I wish to raise a concern regarding the accuracy and clarity of the submitted drawings for plots 27 and 27a.

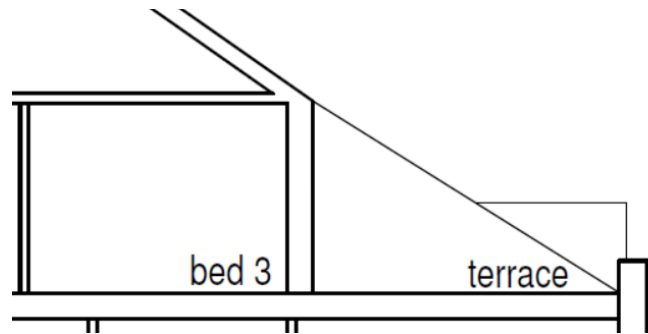
The submitted sections and floor plans appear to show the front terraces as being broadly level with the adjoining internal accommodation, with no indication that a change in level is required between the dwelling and the terrace.

However, dwellings of a similar design (D1) already constructed on the site appear to require steps up from the internal floor level in order to access the terrace. This suggests that the terrace may in reality sit at a higher level than the adjoining internal floor level.

If plots 27 and 27a are intended to utilise the same or similar terrace construction, then the submitted drawings do not appear to accurately show how access to the terraces would be achieved.

Front elevation (1:100)

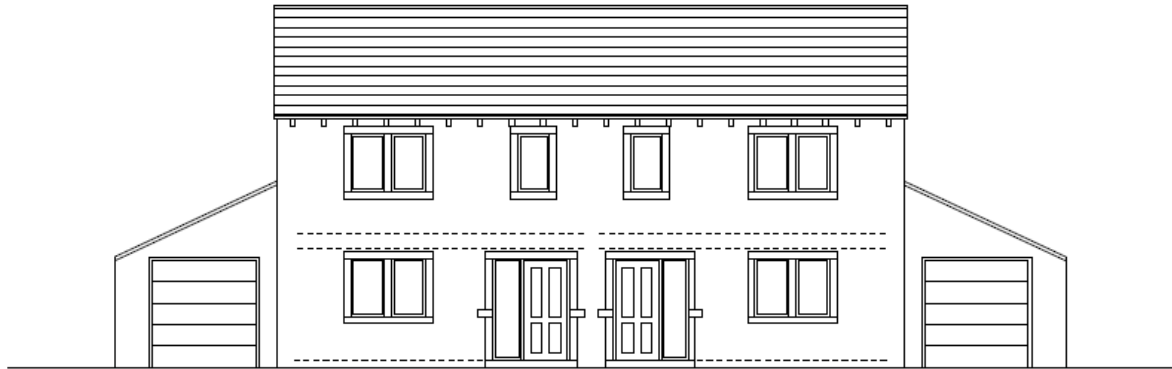
Comparison between approved D1 elevation drawings and D1 dwellings already constructed on site suggests that the level relationships shown on the approved drawings do not necessarily correspond closely to the built form.

The approved elevation does not clearly indicate the stepped threshold arrangement visible in the completed dwelling. However, the completed dwellings exhibit noticeable changes in external levels across the frontage, including differences between driveway, pavement and entrance threshold levels.

This is relevant because the submitted sections for plots 27 and 27a similarly appear to show straightforward level relationships between internal accommodation and the proposed terraces, with no indication that steps or significant level changes may be required.

The existence of apparent level discrepancies between approved D1 drawings and completed D1 dwellings elsewhere on the site raises a legitimate question as to whether the submitted sections for plots 27 and 27a fully and accurately represent the proposed built form.
